Parkmore
Long Mile Road, Ballymount, Dublin 12
Mixed-Use Residential Development

Architectural Design Statement
February 2025

Design Response to LRD Opinion

Figure 4 - Future Walkinstown Park Connection

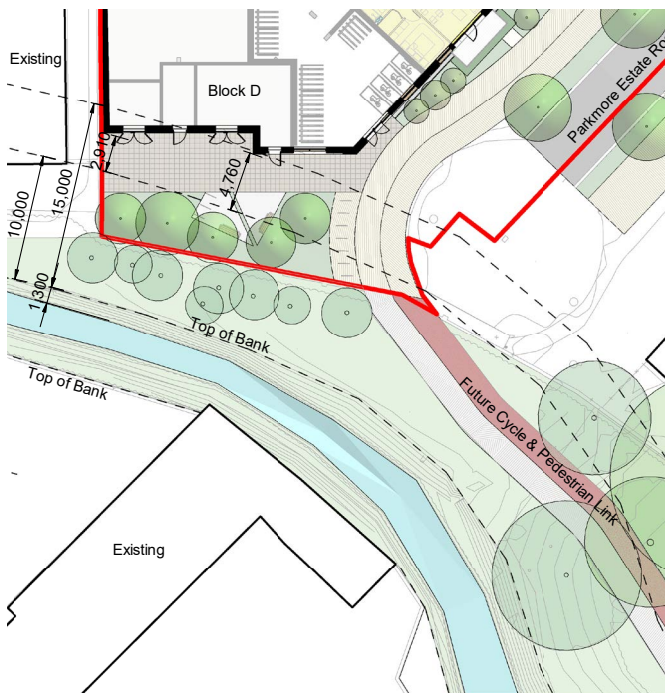
- In the event that a direct connection to Walkinstown Park via the southernmost boundary of the subject site can be secured, provide detailed plans and particulars demonstrating same and showing the boundary treatments with the existing riverbank and park area, cognisant of relevant setback requirements from the river corridor. Taking a balanced, purposive approach to policy implementation, a relaxation in the requirements for a 10m riparian setback free from any paths/lighting (GI3 Objective 3) for riparian vegetation may be warranted, if a direct connection to the park is secured and justification provided. Alterations to the subject site boundary treatment, interface, and the existing vehicular turning circle located to the southern end of Parkmore Industrial Estate road may be required to achieve same. In the event of same, revisions to the redline boundary of lands to which the application relates will be required and relevant consent for any lands not within the ownership of the applicant should be provided.

The future connection to Walkinstown Park is outside the ownership of the current site and subject to agreement with other landowners during future planning applications in the area. The proposed design envisages connections to the park along the Parkmore Estate Road and along the river bank from Robinhood Road. A pocket park is provided along and inside the southern boundary of the site to facilitate the future greenway along the river. The pocket park is within the site boundary but outside the future City Edge 10m riparian strip along the river bank. The pocket Park will assist facilitate future pedestrian and cyclist links from the Robinhood Road to Walkinstown Park. The proposed future City Edge Riparian strip is not within the ownership boundary of the site.

Figure 7 - Site Strategy Diagram

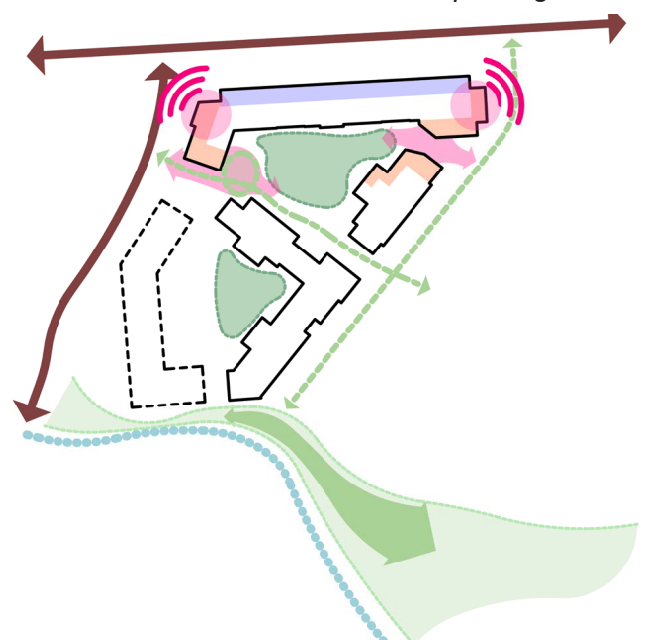
- Demonstrate that the proposed

development would provide for placemaking and ensuring realisable linkages with nearby services and amenities.

Within the Architectural Design Statement, Section 1 Context and Section 2 Connections, it is shown how the proposed design provides or facilitates the future delivery of linkages as envisaged by the City Edge Strategic Plan. Good neighbourhoods are well connected places to amenities with routes that are pleasant, convenient and safe to use.

In Section 1 of the Design Statement we also carry out an assessment of the site as part of a Regeneration Zone. There are five criteria to be assessed, as set out in the SDCC Development Plan, and our response to two of these criteria in particular provide an answer to the question raised here:

Figure 9 - Extract of Long Mile Rd showing kerbside parking.

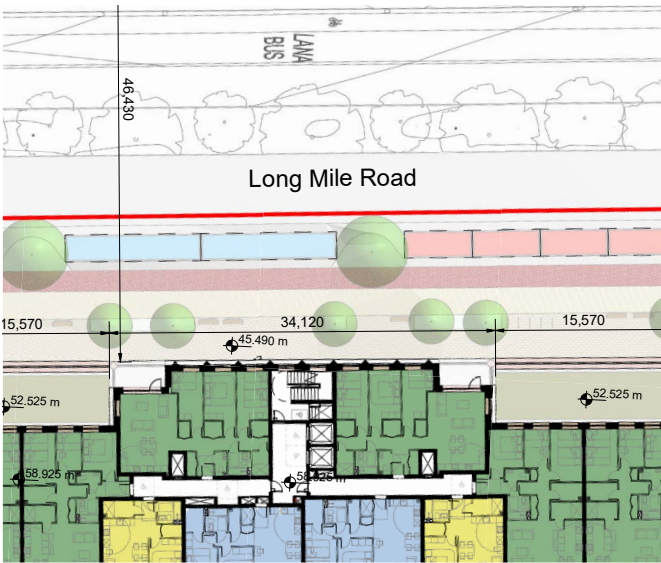
- Demonstration of set down/parking facilities

serving the creche and commercial units.

Response:
Section 11 within the Architectural Design Statement (Parking) demonstrates how parking is dealt with across the site in order to provide sufficient parking to cope with demand in a way that does not overwhelm the appearance and amenities of the public realm. Diagrams within the report clearly show parking for all stakeholders across the site. Car parking and loading bays serving the creche and commercial units is at grade along the Long Mile Road in close proximity to each of these uses.
